PD 1031

**Re: Administrative Relief request for Waterway Planned Development
No. 1031, 1500 West Webster Avenue**

WPD 1031

Waterway Planned Development Number *1031*.

Proposed Site Plan.

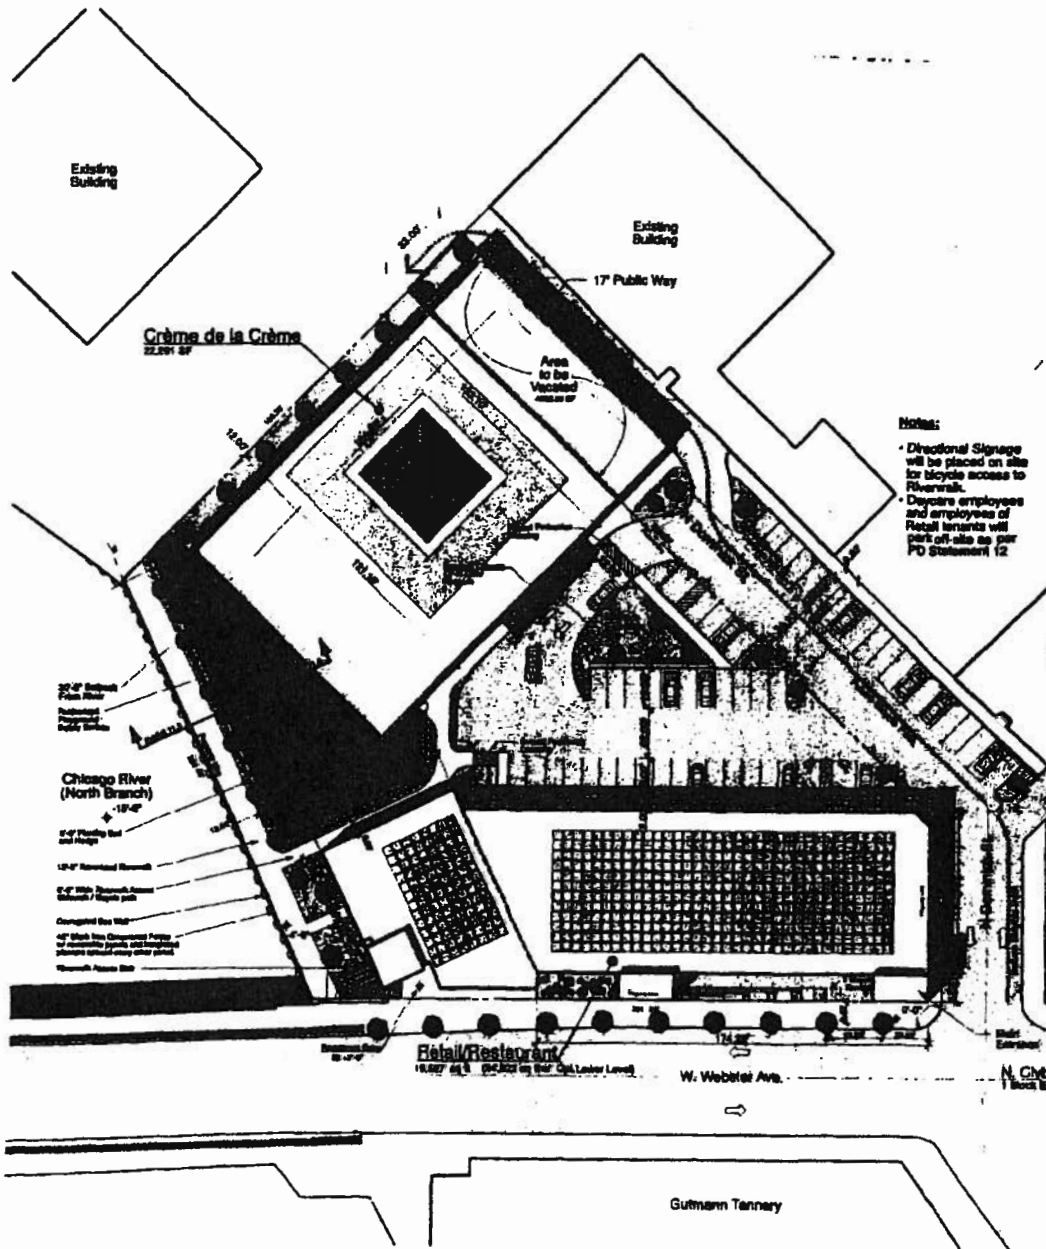
- Reduce the parking within the boundaries of the development site from 27 to 25 parking spaces as a result of Fire Prevention Bureau requirements. Pursuant to agreements between the Applicant and the early childhood learning/day care center and tenants of the retail-restaurant building, employees of both the early childhood learning/day care center and of the retail-restaurant tenants will not park in the 25 off-street parking spaces.

To accommodate this requirement, agreements shall be executed with the owner of the mixed-use retail/movie theater development located immediately south of West Webster Avenue and east of North Dominick Street to provide at least 20 off-site parking spaces. All employees of the early childhood learning/day care center and tenants of the retail-restaurant building shall park in these off-site spaces. Any spaces not required for employees shall be available for patrons of the retail-restaurant building. Therefore, the off-site parking spaces shall increase from 16 to 20 spaces, resulting in an increase from 43 to 45 in the minimum number of off-street parking spaces.

- Redesign the retail-restaurant building by adding 3,840 square feet of commercial space on the second floor. There is no change in the permitted floor area ratio of 0.73.
- Substitute the following PD Exhibits, prepared by Pappageorge/Haymes Ltd, and dated May 5, 2008:
 - Exhibit 1 Bulk Regulations and Data Table
 - Exhibit 5 Proposed Site Plan

Right-Of-Way Adjustment Plan.

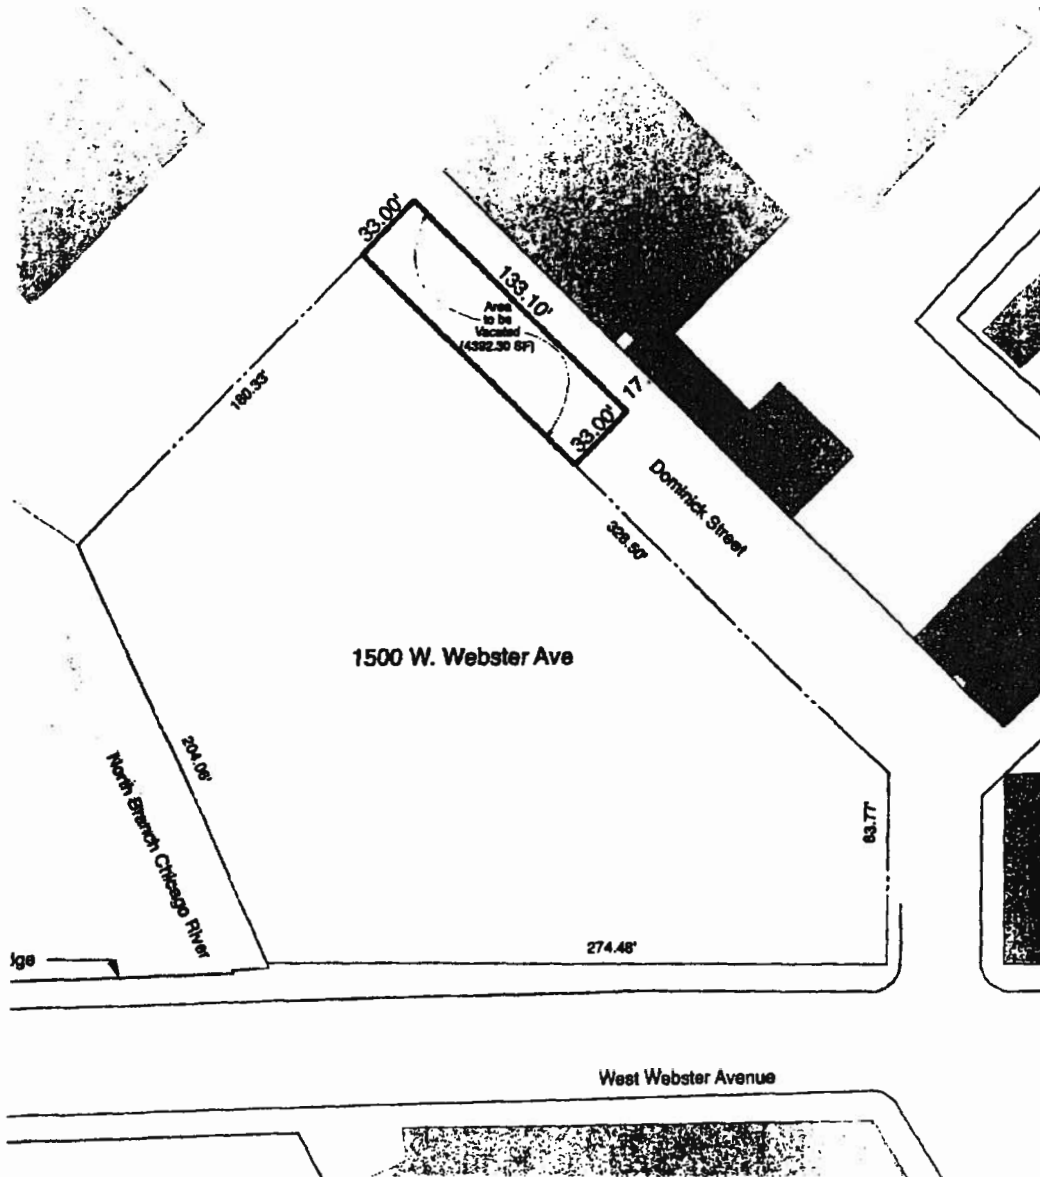
- Abandoning the proposed vacation of North Dominick Street.
- Redesigning the early childhood learning center by reducing the width of the building so as not to extend into the North Dominick Street right of way and extending the building footprint for several feet in a southerly direction.
- Reconfiguring the parking to provide 27 parking spaces within the boundaries of the development site. Approximately 34 additional parking spaces will be located within the improved North Dominick Street right of way. These spaces will not count towards the project's required off-street parking. Employees of the early childhood learning center and retail-restaurant uses will continue to be required to park off-site. In addition, the minimum number of off-street parking spaces will be reduced from 55 to 43.
- Redesigning the retail-restaurant building.
- Substituting the following PD Exhibits:

Exhibit 1	Bulk Regulations and Data Table (1-17-08)
Exhibit 3	Planned Development Boundary and Property Line Map (8-21-07)
Exhibit 4	Land Use Plan (8-21-07)
Exhibit 5	Site Plan (8-21-07)
Exhibit 6	Landscape Plan (8-21-07)
Exhibit 7	Right of Way of Adjustment Plan (exhibit deleted as a result of abandonment of proposed vacation of Dominick Street) (8-21-07)
Exhibit 8	Riverwalk Access Plan (8-21-07)
Exhibit 9	Right of Way Improvement Plan (8-21-07)
Exhibit 10	Plan for Green Design Elements (8-21-07)
